# S E R V I C E N O T E

## HP E5100A/B Network Analyzer

# Monochrome LCD may become difficult to read due to loss of brightness

Figure 1. J20 Connector

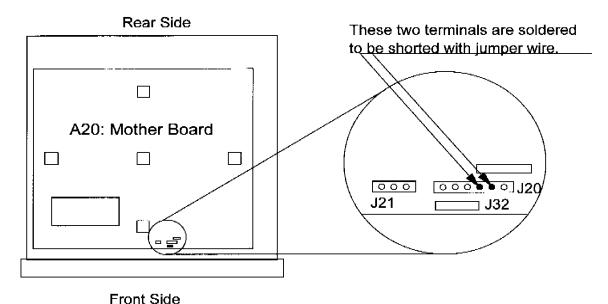
The J20 connector is located on the A20 mother board, and it has six terminals, as shown in Figure 1.

- 1. The second and the third terminal from line sw side should be soldered to be shorted with jumper wire. This modification is for reducing the back-light display current, resulting the life span of the LCD display will be extended.
- 2. Install the outer cover, the strap and the rear feet by tightening the screws.
- 3. Inspect the power on sequence.
